STAFF RECOMMENDATION
1104 Fatherland Street
September 21, 2016

Application: New construction - addition
District: Lockeland Springs-East End Neighborhood Conservation Zoning Overlay
Council District: 06
Map and Parcel Number: 08313009700
Applicant: John Root, rootARCH
Project Lead: Melissa Sajid, melissa.sajid@nashville.gov

Description of Project: Application is to construct a rear addition. No changes are proposed to the existing historic structure.

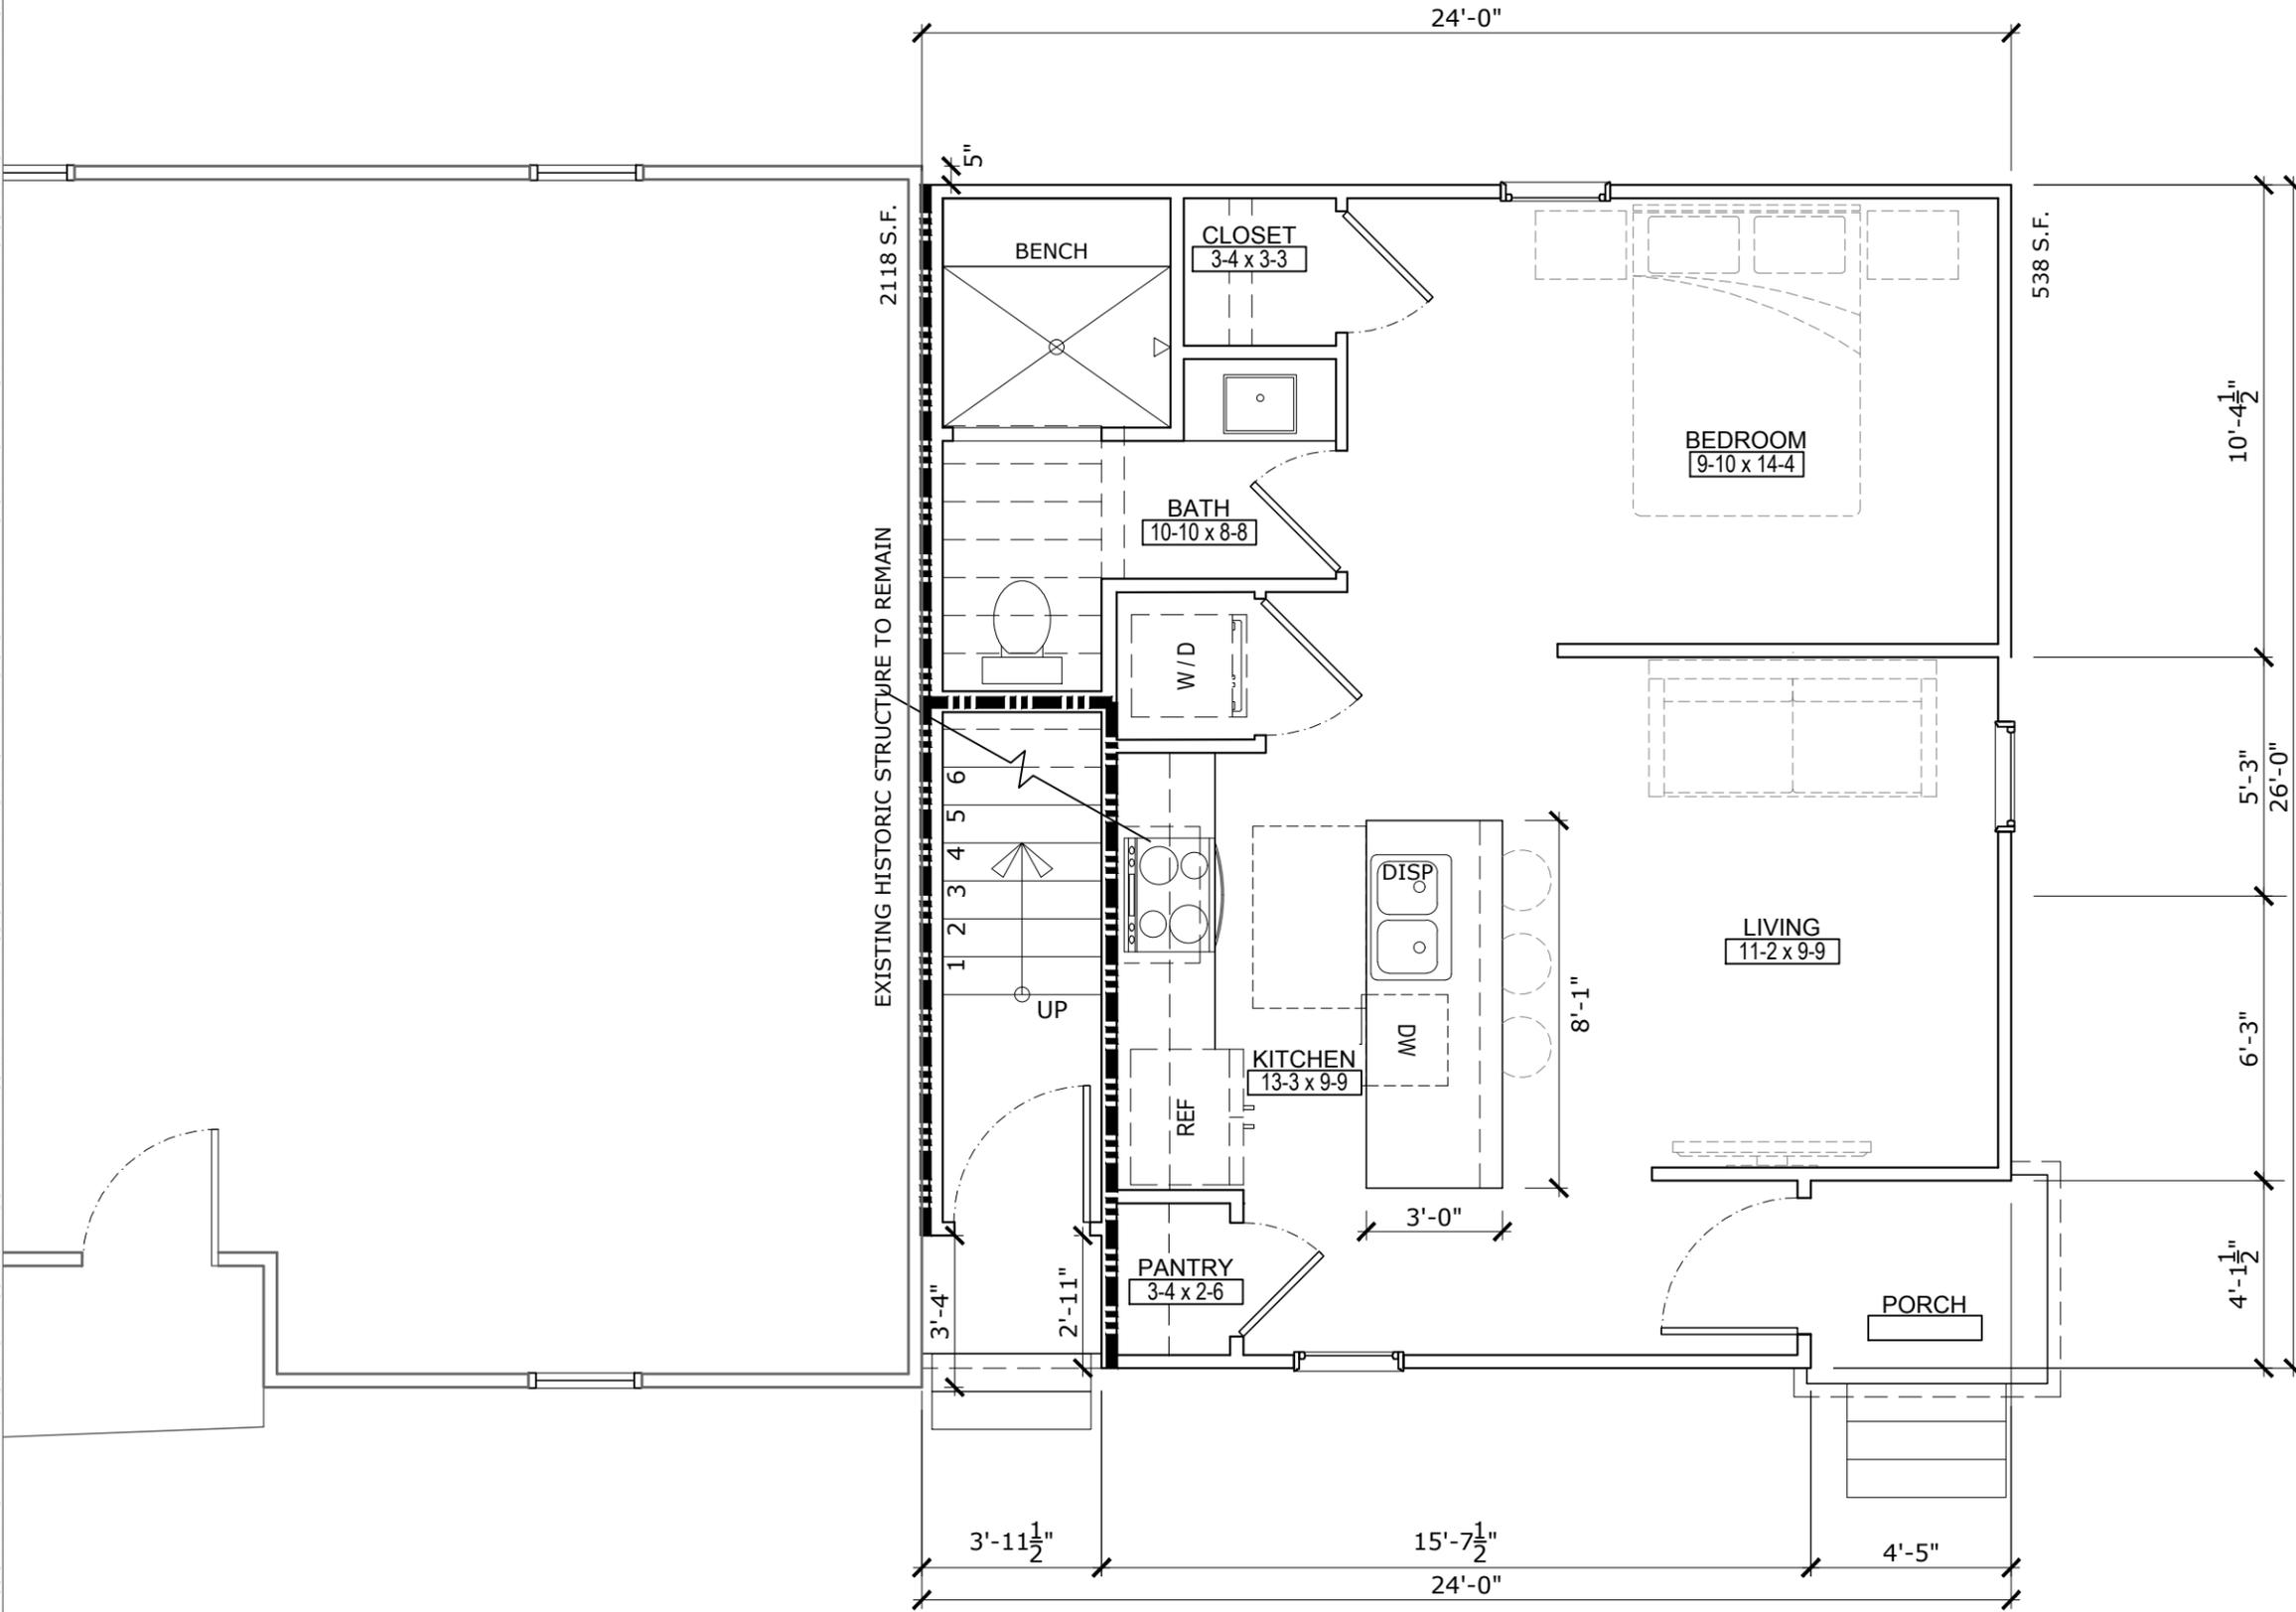
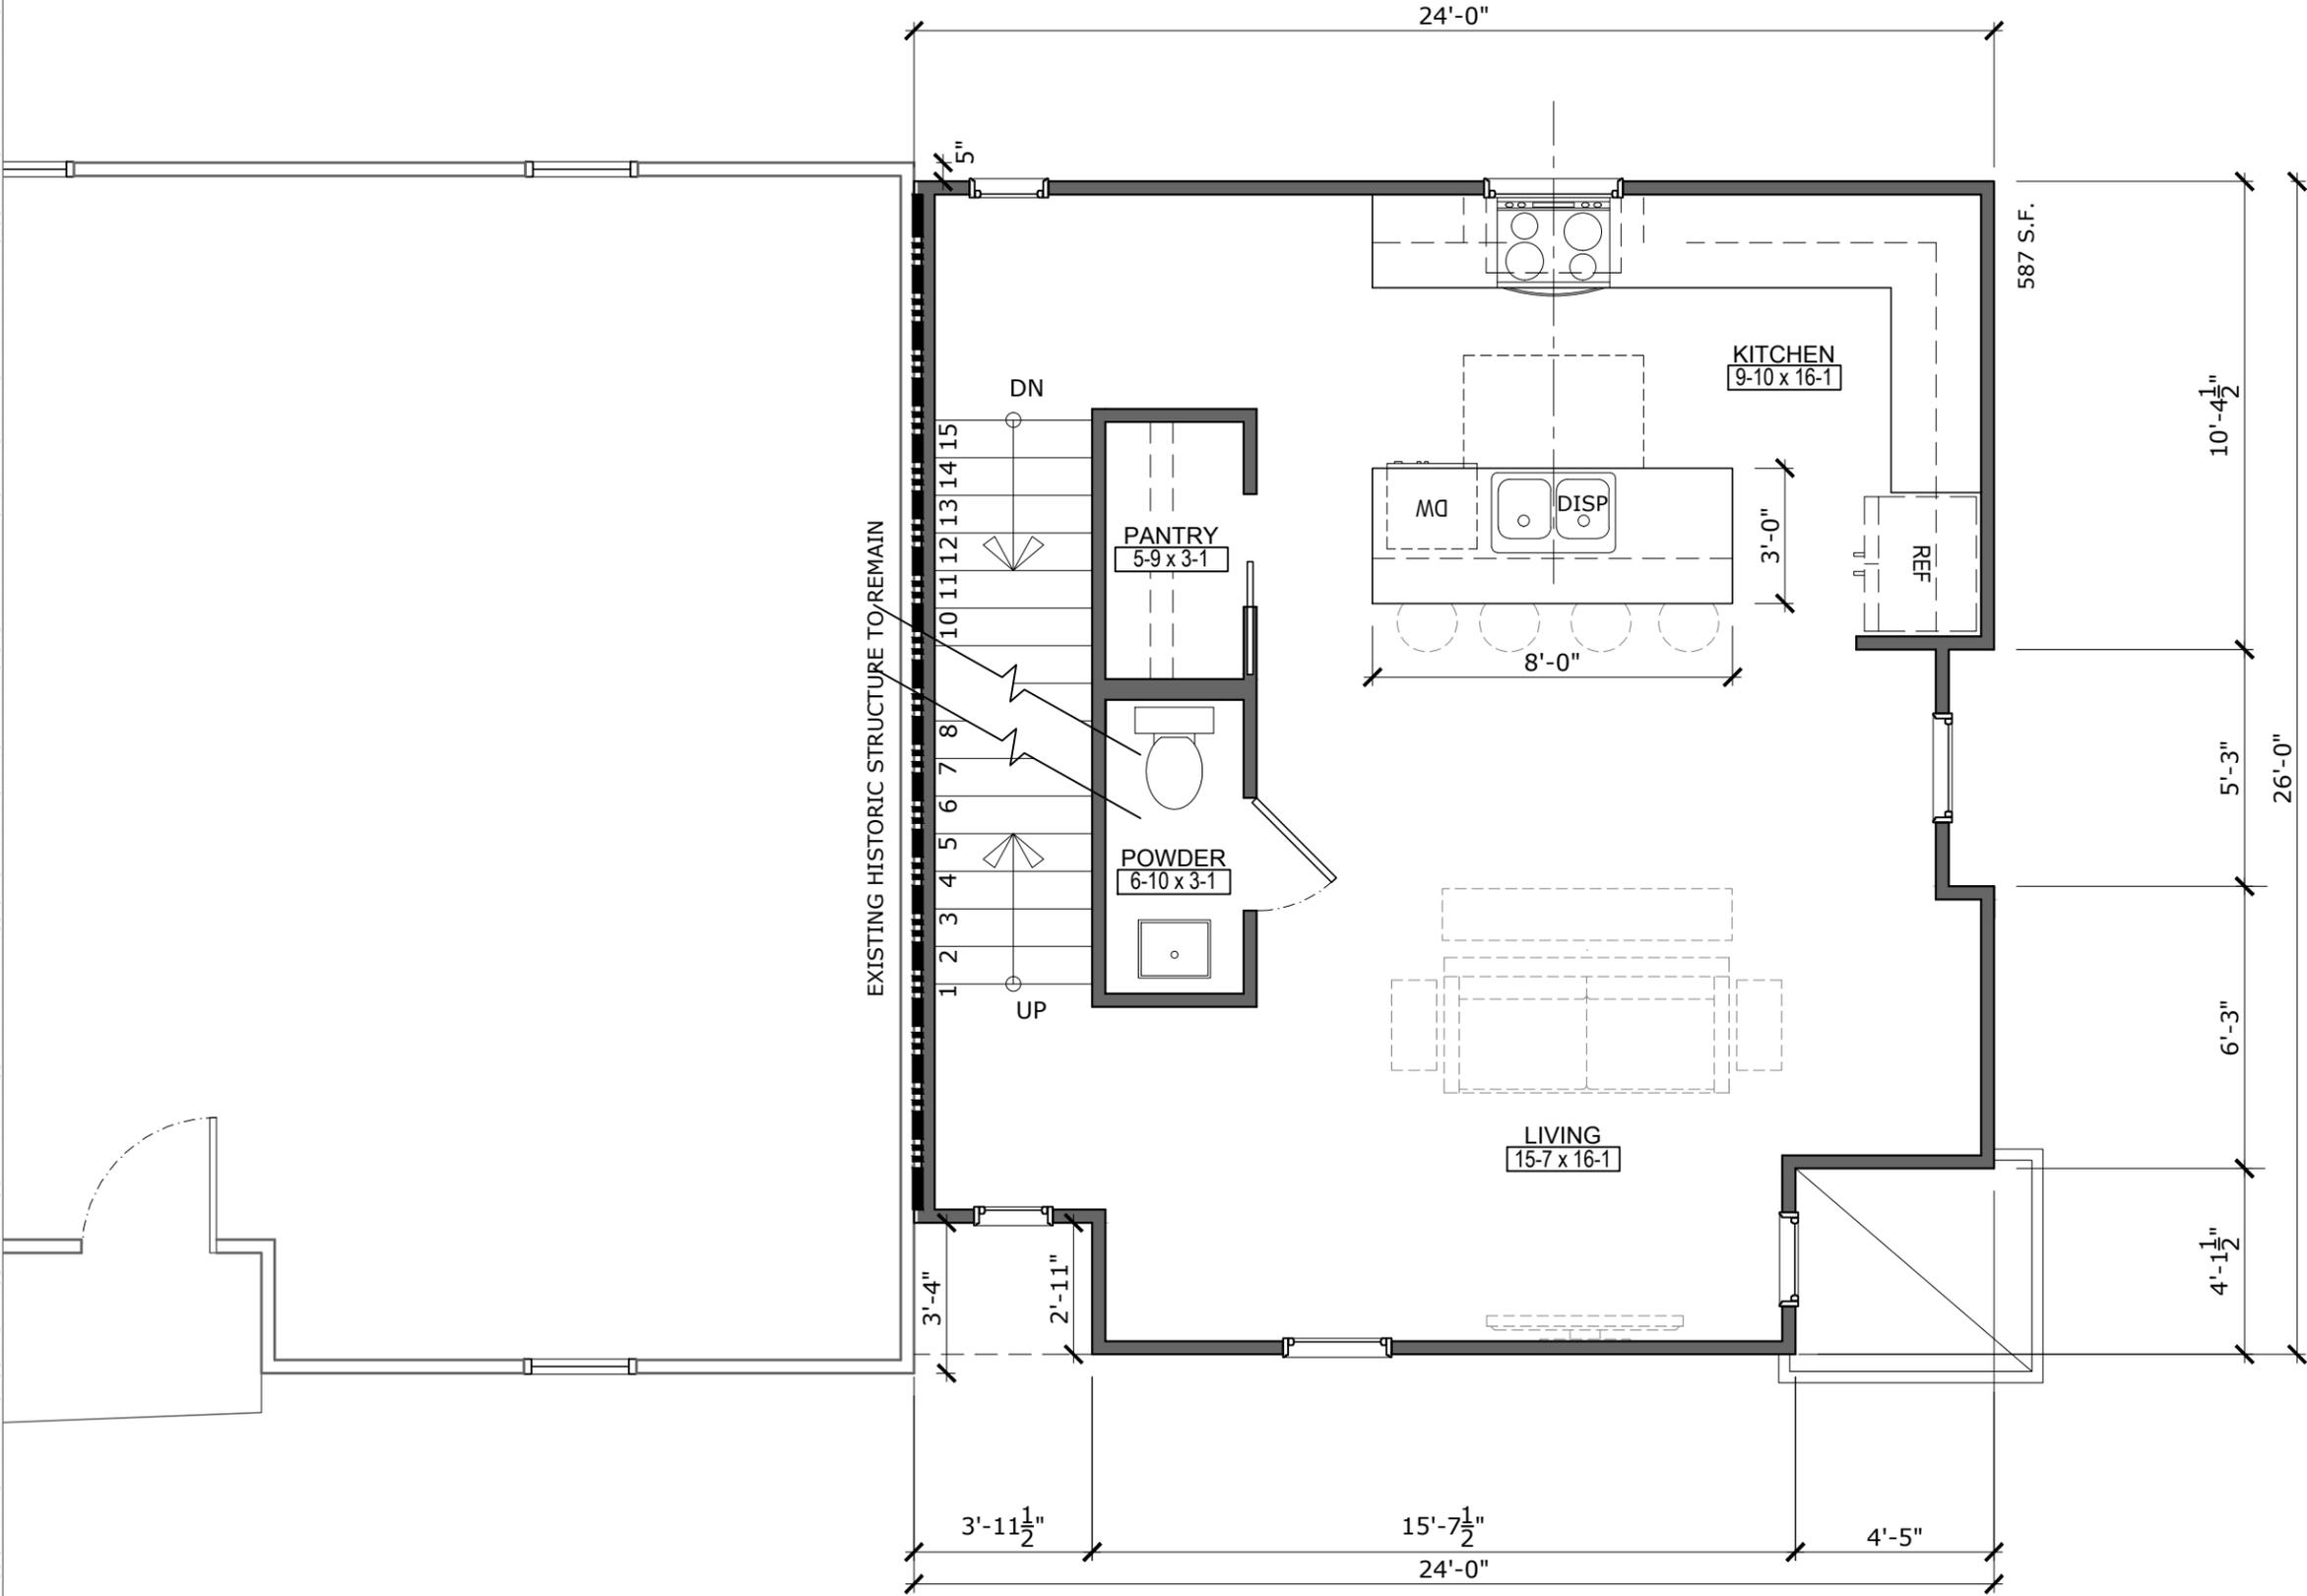
Design, Location & Removability: The new construction is located at the rear of the historic house, in accordance with design guidelines. However, the addition does not meet the design guideline that requires the new construction to be inset one foot (1') per story from the rear corners of the historic house. As proposed, the addition sets in three feet, four inches (3'-4") from the right corner and five inches (5") from the left on the basement and first floor levels and five inches (5") from each corner on the second floor level. The applicant contends that the proposed insets are sufficient since the rear corners are obscured by existing bump outs located closer to the front of the historic structure. The 1914 Sanborn map, however, shows that the existing rear corners are likely original to the structure (See Figure 2). Setting in the addition one foot (1') per story helps to ensure that the new construction is distinguished from the existing historic structure, allows the full form of the original building to be kept intact and would allow for original conditions to be restored, if desired in the future. As proposed, the addition does not meet this requirement.

Staff finds that the rear addition is inappropriate as it does not meet the design guidelines for removability. The project does not meet Sections II.B.10.a.
